SUBDIVISION REVIEW SHEET**CASE NO.:** C8-2023-0077.0A**COMMISSION DATE:** June 13, 2023**SUBDIVISION NAME:** 7205 Cameron Road**ADDRESS:** 7205 Cameron Road**APPLICANT:** Sierra Cameron Acres (Matthew Shaw)**AGENT:** WGI (Justin Celentano)**ZONING:** GR-MU-NP (Community Commercial – Mixed Use)**NEIGHBORHOOD PLAN:** Coronado Hills**AREA:** 2.413 acre (105,110.28 sf)**LOTS:** 1**COUNTY:** Travis**DISTRICT:** 4**WATERSHED:** Fort Branch**JURISDICTION:** Full Purpose**SIDEWALKS:** Sidewalks will be constructed along adjacent roads.**VARIANCE:** none**DEPARTMENT COMMENTS:**

CITY OF AUSTIN –DEVELOPMENT SERVICES DEPARTMENT
SUBDIVISION APPLICATION – MASTER COMMENT REPORT

CASE NUMBER: C8-2023-0077.0A
UPDATE: U0
CASE MANAGER: Cesar Zavala Email: cesar.zavala@austintexas.gov

PROJECT NAME: 7205 Cameron Road (a.k.a. Cairn Point subdivision)
LOCATION: 7205 Cameron Rd.

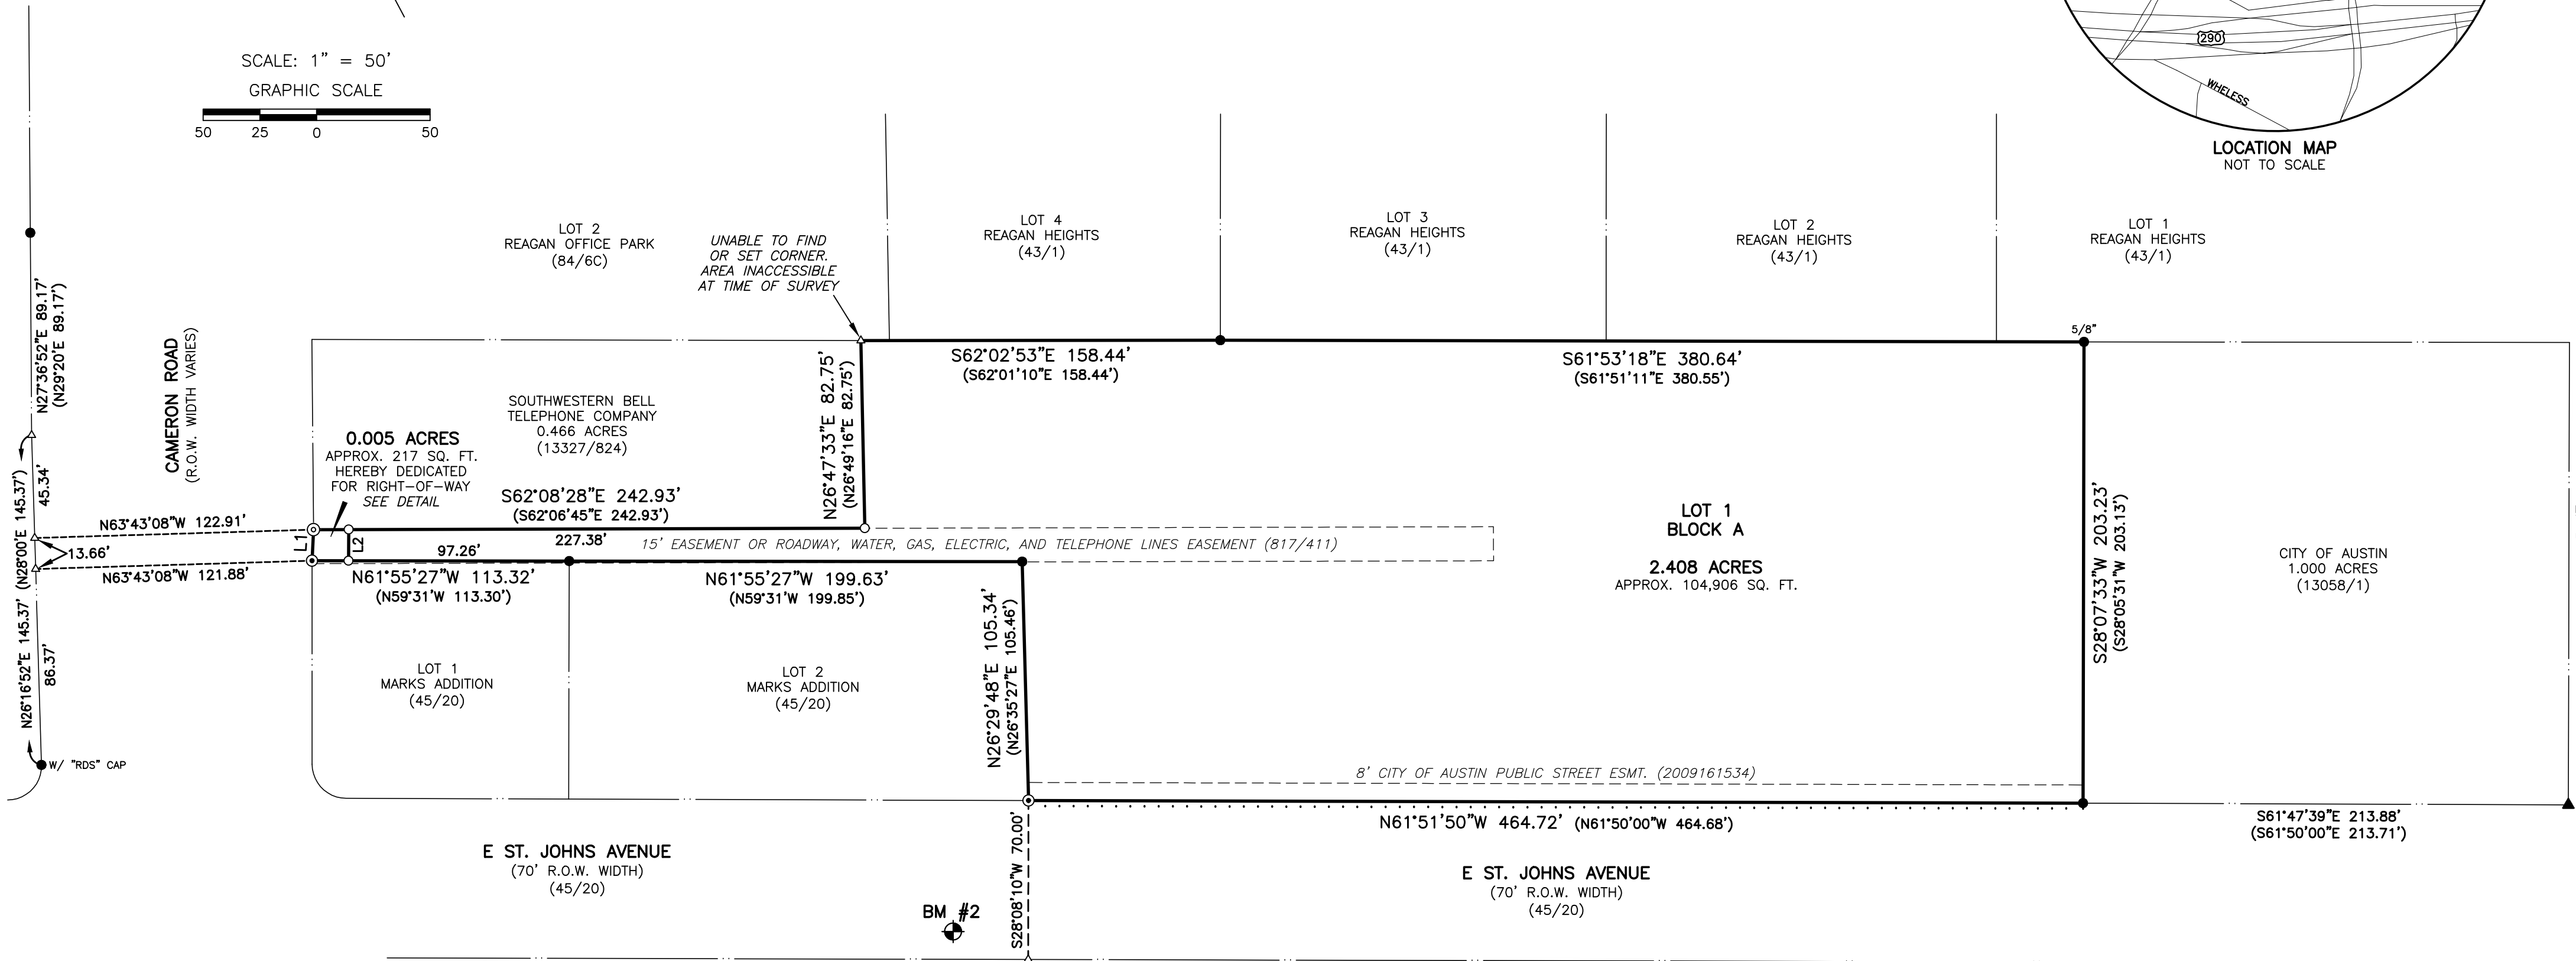
- ATD 1. The ASMP requires 154 of right-of-way for Cameron Rd. Dedicate 77 feet of right-of-way from the existing centerline in accordance with the ASMP (LDC 25-6-55). Unclear if proposed dedication is sufficient. Please show measurement from center line of Cameron to new property line to verify 77' width.
- ATD 2. The ASMP requires 72 of right-of-way for St. Johns Ave. Dedicate 36 feet of right-of-way from the existing centerline in accordance with the ASMP (LDC 25-6-55). The current easement is not the correct document and should be dissolved.

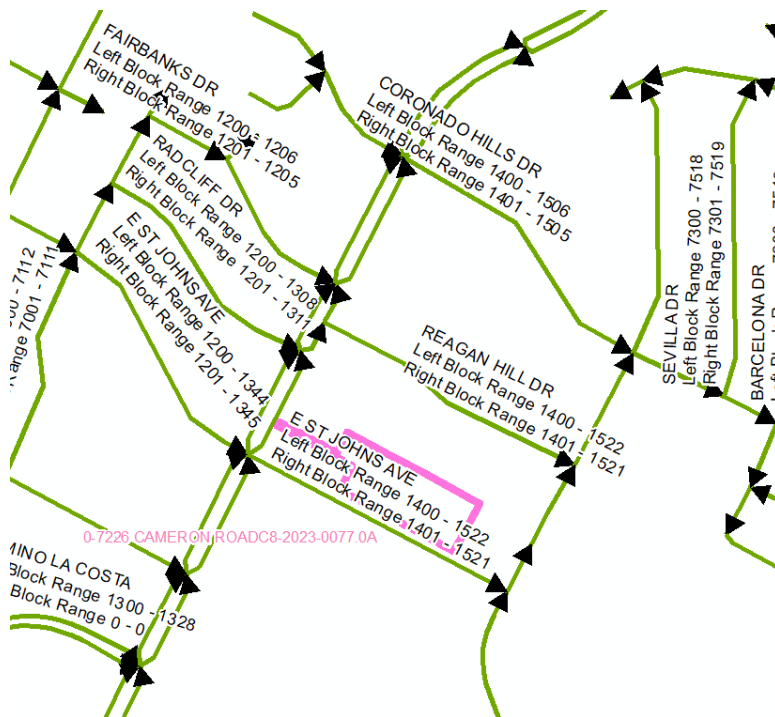
AD2: Please remove all street labels in the vicinity map for the following:

1. Please update label for **E ST JOHNS AVE** the street type AVE and the directional E must be included
2. Please update label for **REAGAN HILL DR** the street type DR must be included

3. Please update label for **CORONADO HILLS DR** the street type DR must be included
4. Please update label for **FAIRBANKS DR** the street type DR must be included

5. Please update label for **MC KIE DR** the street type DR must be included. It must be labeled as 3 words
6. Please update label for **WESTHEIMER DR** the street type DR must be included. The current label has punctuation

7. Please update label for **GRAND CANYON DR** the street type DR must be included
8. Please update label for **BLESSING AVE** the street type AVE must be included

9. Please update label for **ATHLETIC DR** the street type DR must be included
10. Please update label for **E US 290 HWY** the directional E must be included

11. Please update label for **WHELESS LN** the street type LN must be included

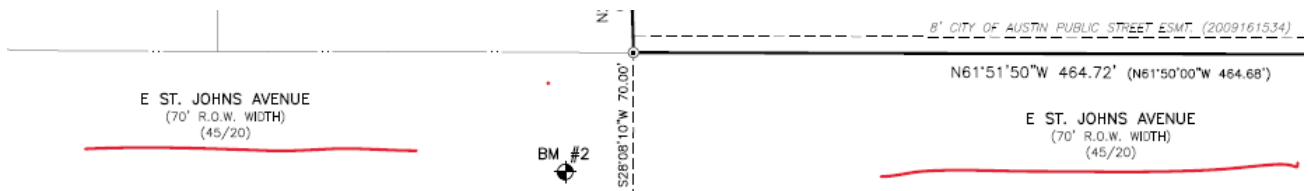
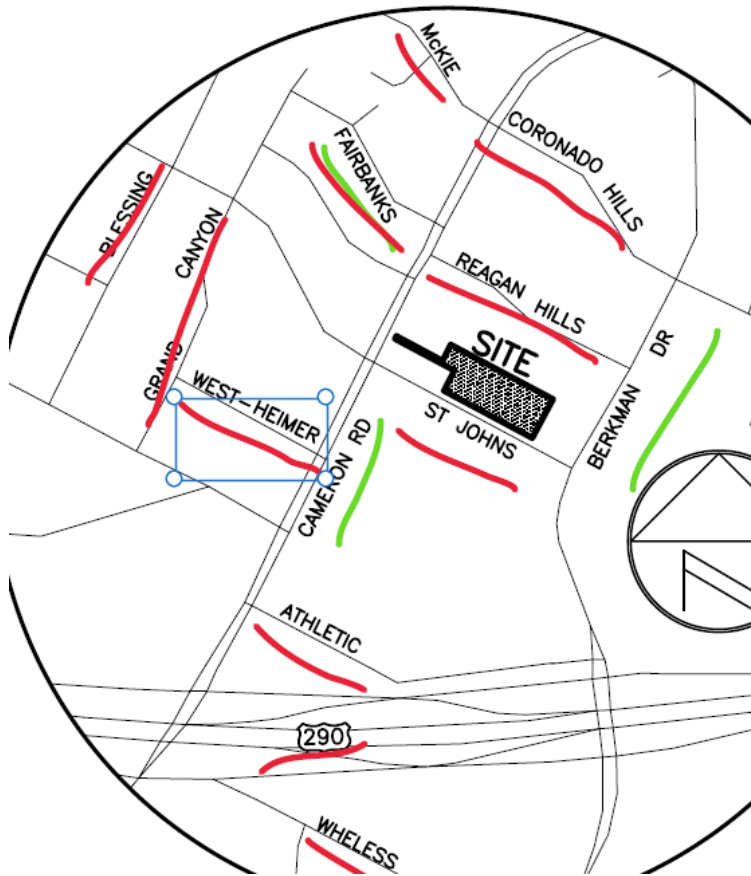
AD3: Please remove all forms of punctuation after abbreviating street types or directionals

NOTE: Punctuation or diacritical marks cause confusion for first responders

NOTE: Reagan Hill Dr is labeled as Reagan Hills
